LIST OF PROPOSED CHANGES to
22/01841/S73 APPROVED PLANS

Land adjacent to Orchard Barn
Hexton Road, Lilley
Hertfordshire LU2 8NA

PROPOSED PLANS

301

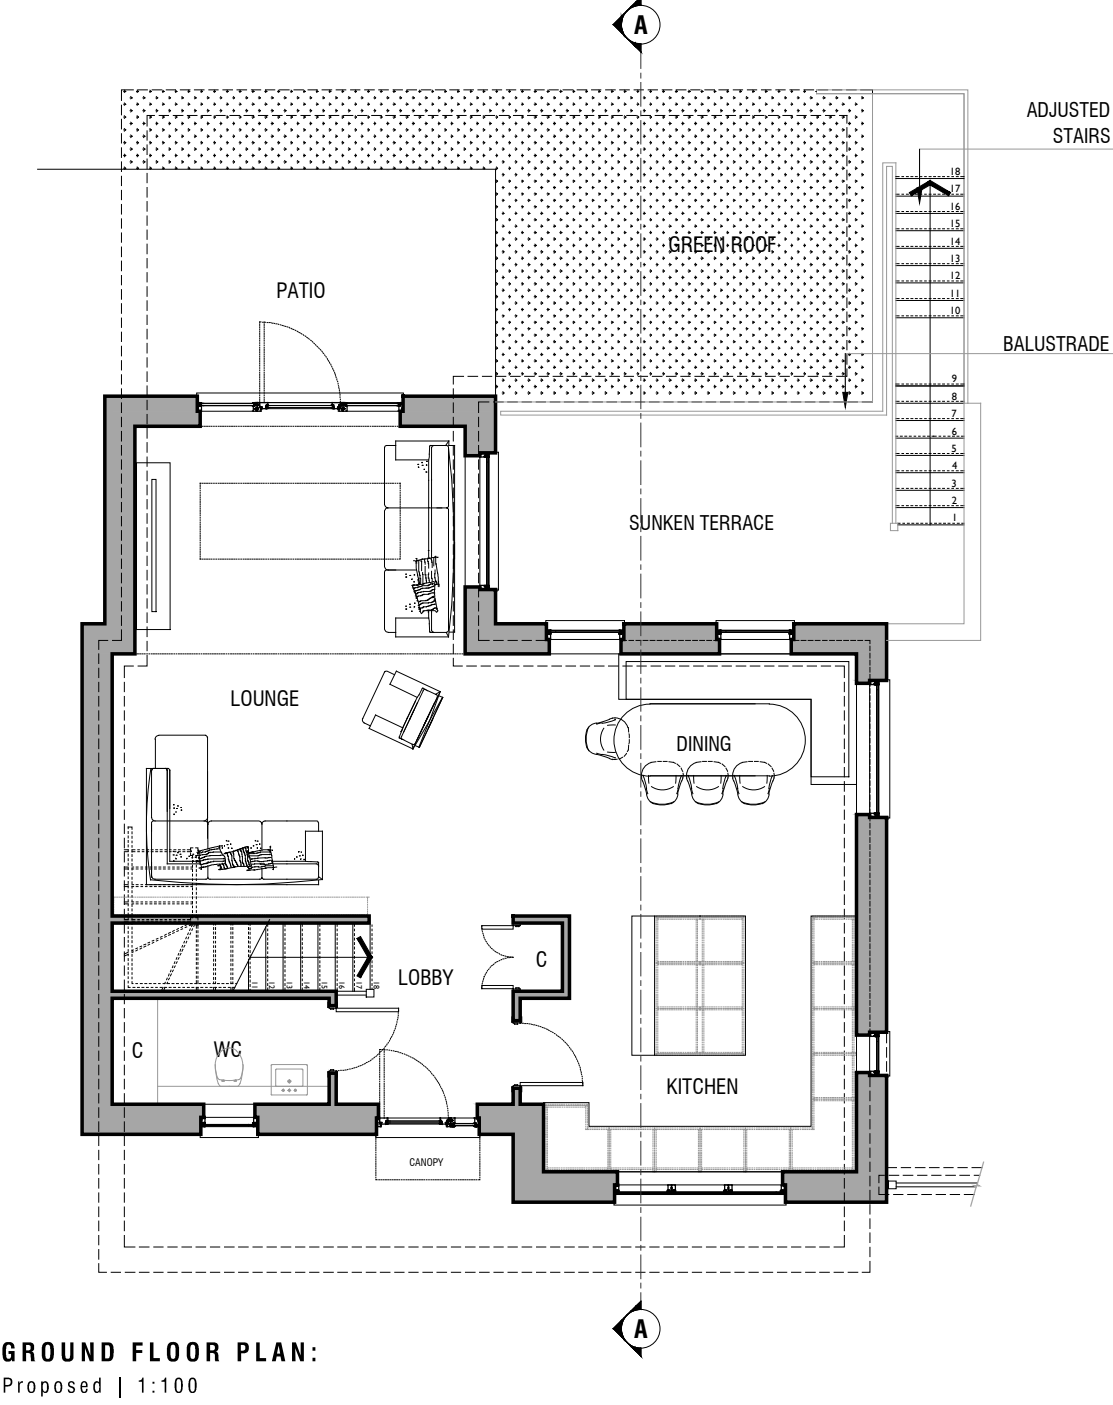
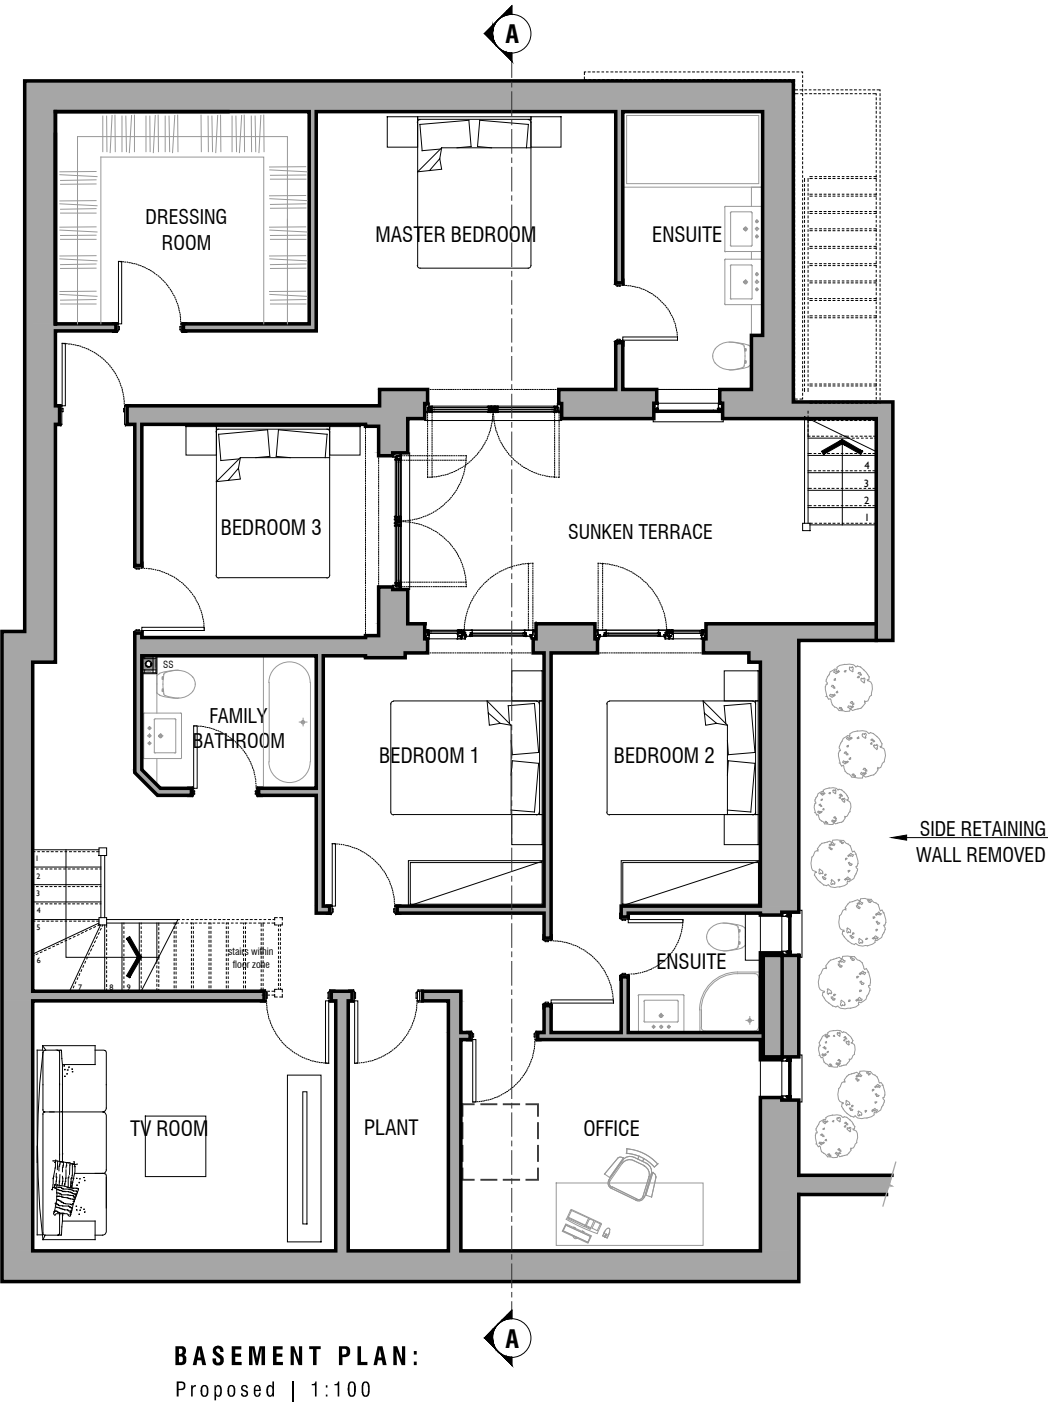
- Stairs from sunken terrace reconfigured
- North East corner of basement slightly above ground
- Side retention wall removed - not required due to existing levels lower than expected
- Parking spaces adjusted
- Canopy added to front door

A 29.10.2024 Amend stairs and levels to rear garden
